KARACHI MUNICIPALITY.

ORDER UNDER SECTION 96 (2) OF ACT, III OF 1901.

I have to inform you that the plan submitted by you for building
Houses on plot No. 53 sheet No. 142 140/141 making

Re: Plot No. 53 . Sheet Sub-2 . Market Qr.

SECTION ON A.B.

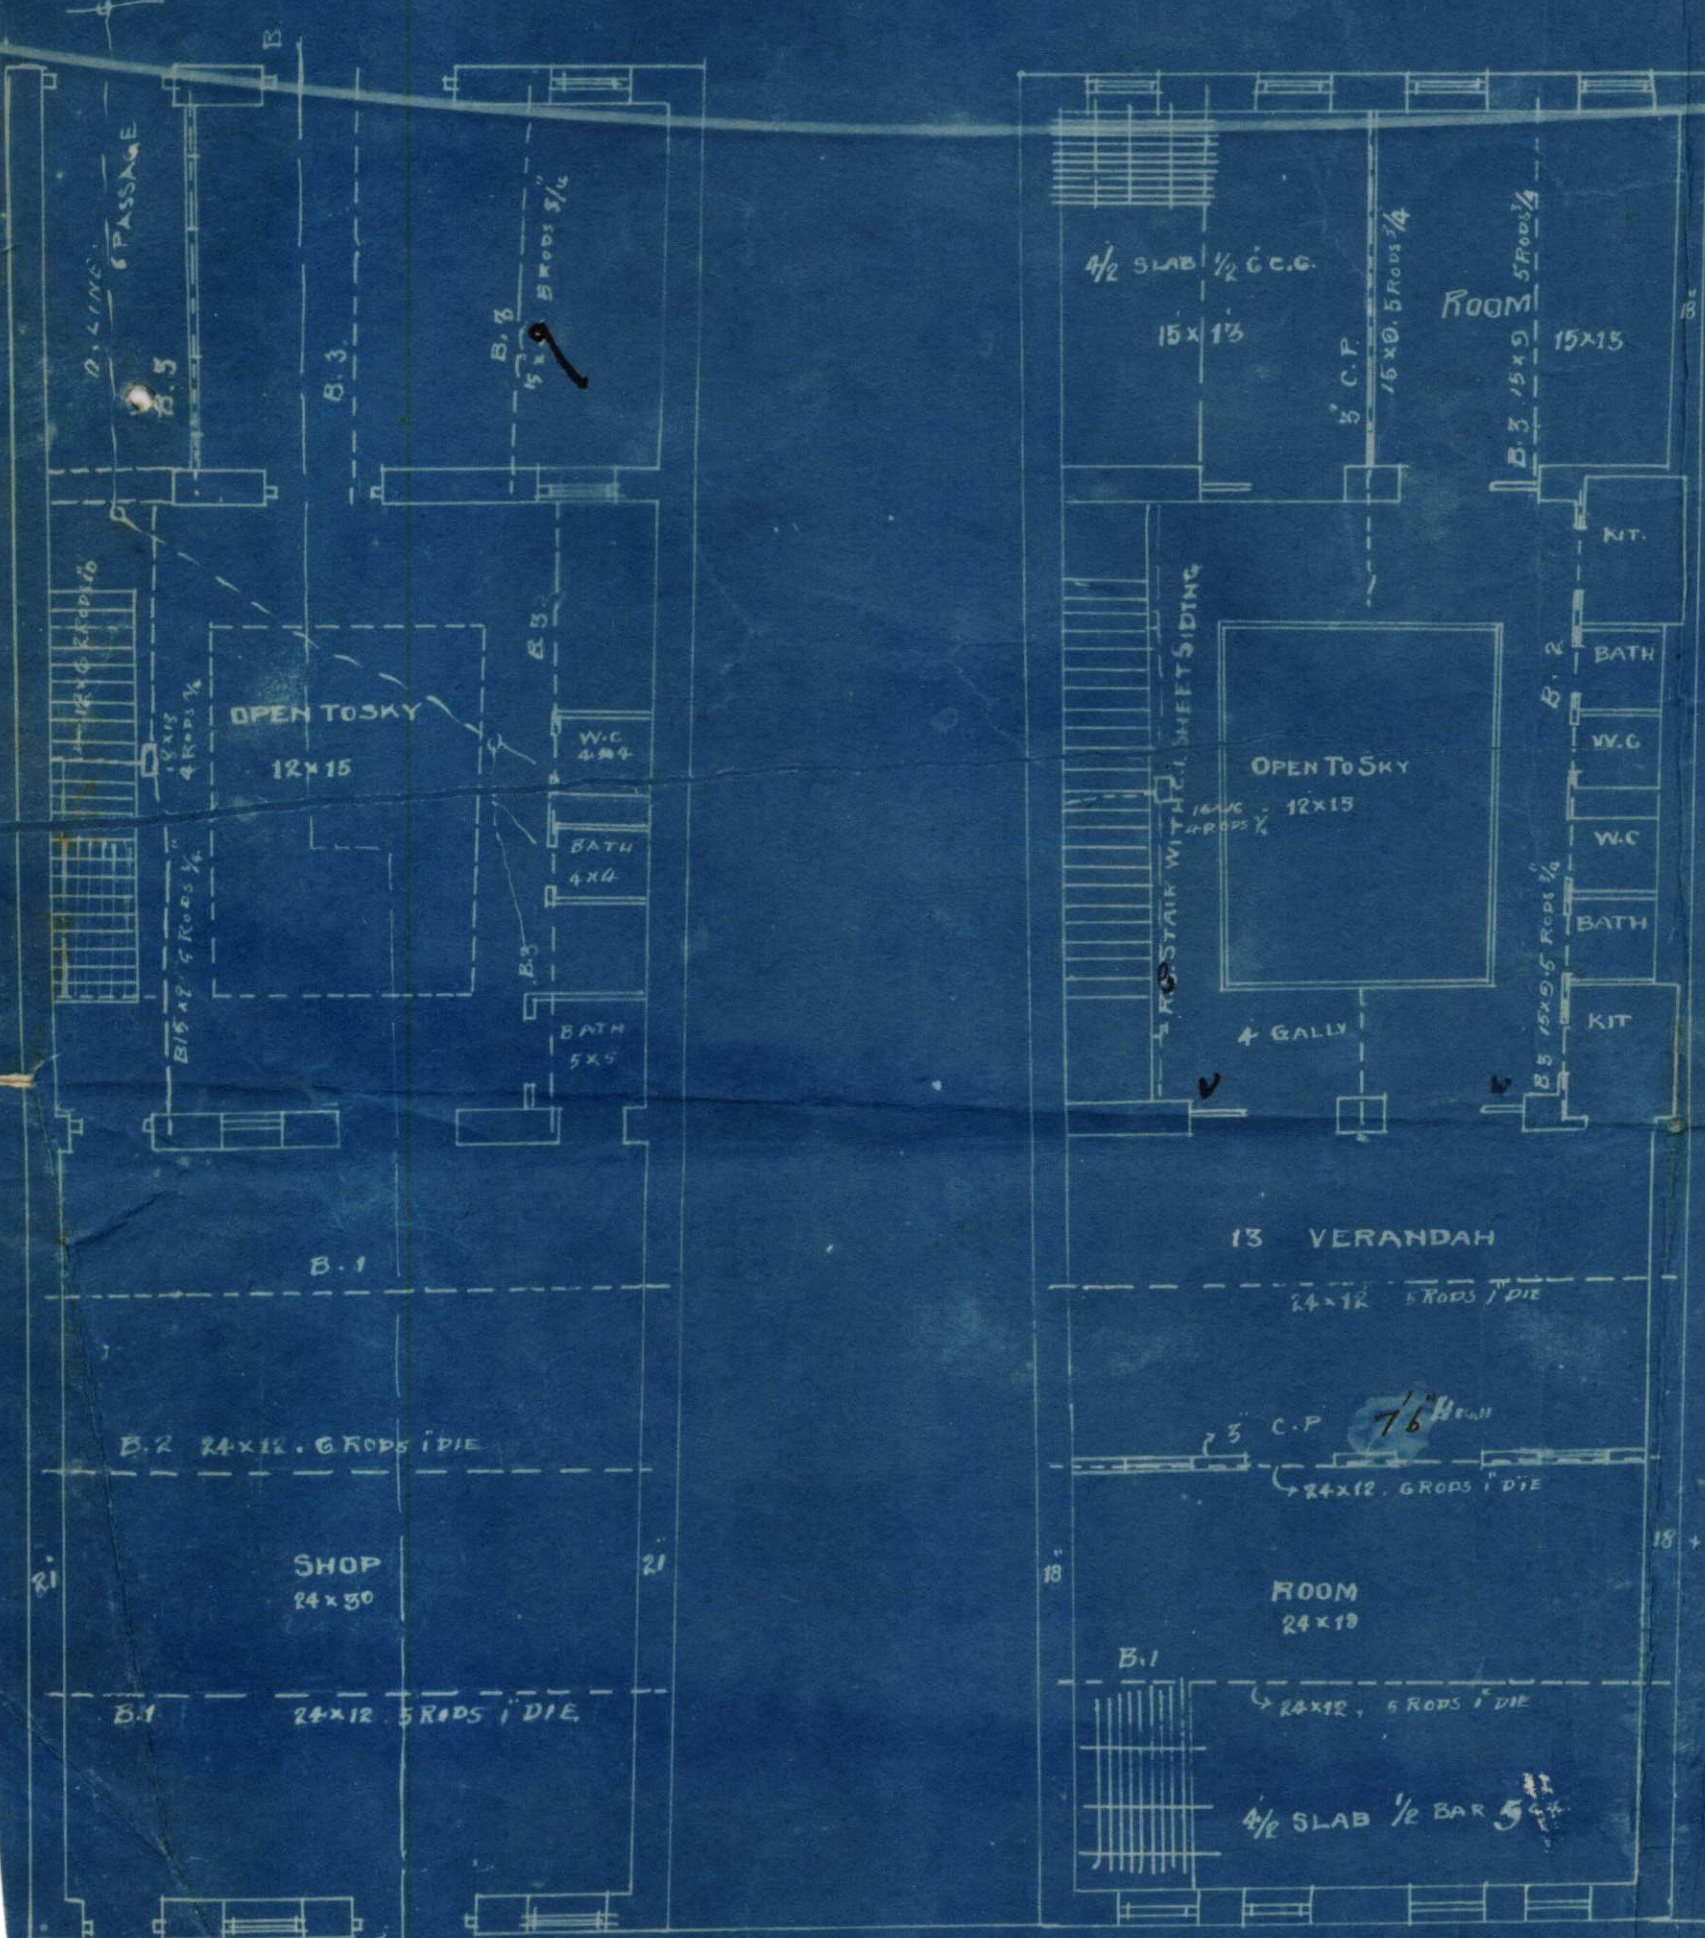
- (1) Sanitary arrangements must be shown on ground plan.
- (2) Partition wall between room & verandah to be only 7'-6" high. One cannot have a verandah & then a more than 3'-6" gallery. 13' verandah is really a room. Posts or columns are required to support the p. wall of sanitary block & the staircase passage. Sections of the R.C. beams to be given.
- (3) Reinforcement of beams do not tally in plan & section. Reinforcement of staircase to be shown.
- (4) Passage to be marked 6' 1/2" clear to be placed 5' c to c.
- (5) Section line A-B must be marked.
- (6) R.C. post & beam to be given under the stairs platform.
- (7)
- (8)
- (9)

- (1) Sections of the R.C. beams be given.
- (2) Reinforcement of beams does tally in plan & section.
- (3) Reinforcement of staircase be shown.
- (4) Passage be marked 6'.
- (5) $\frac{1}{2}$ " bars be placed 5' c/c.
- (6) Section line A.B must be marked.
- (7) R.C. Posts and beams be given under the stair platform.

GROUND FLOOR

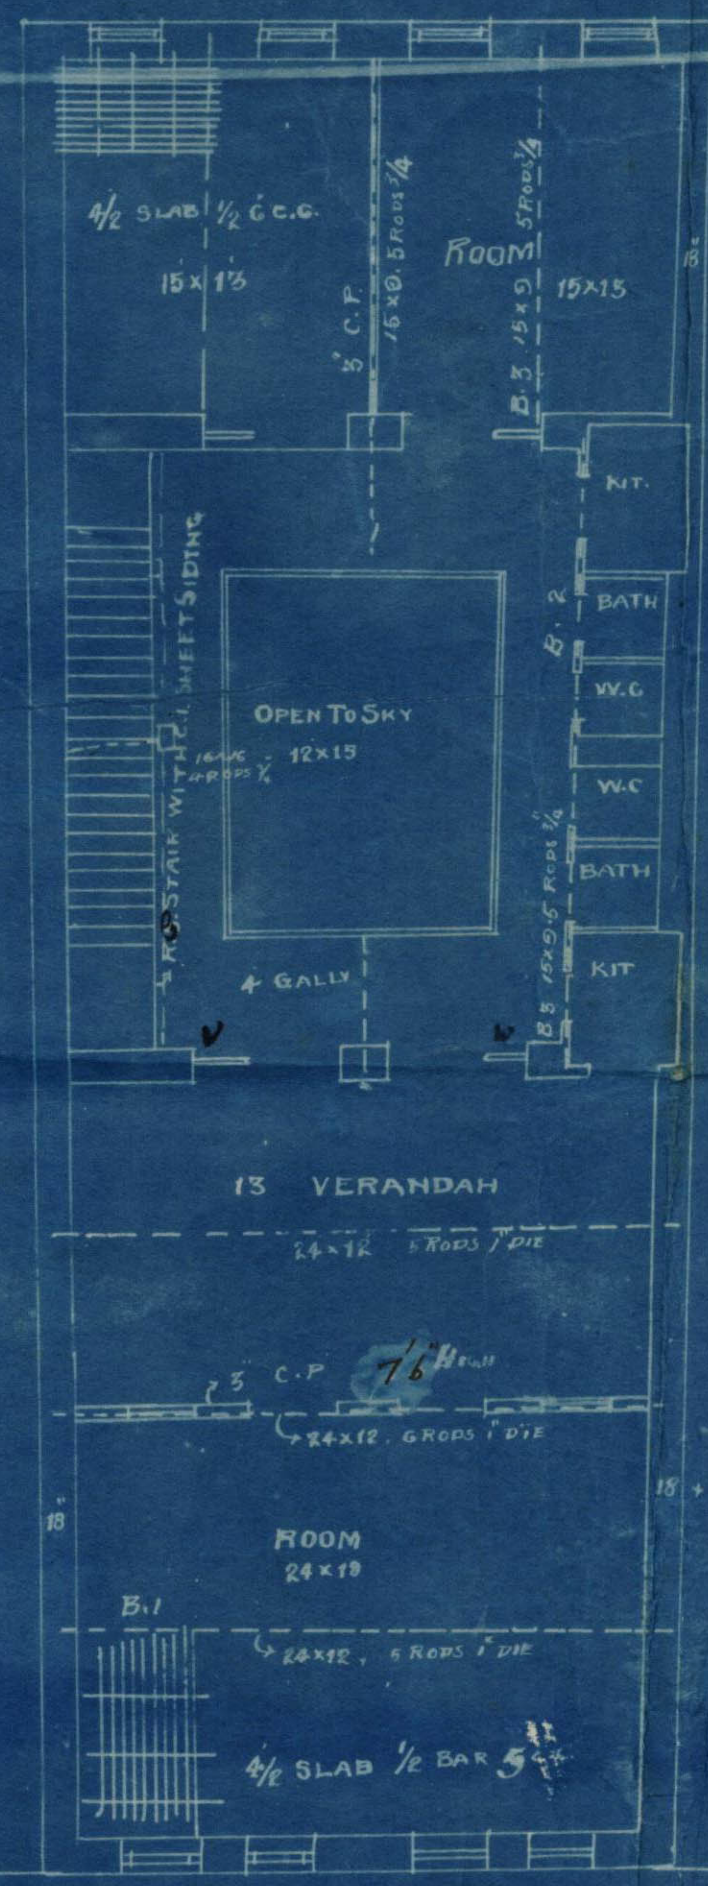
No sanitary arrangements shown on the first floor
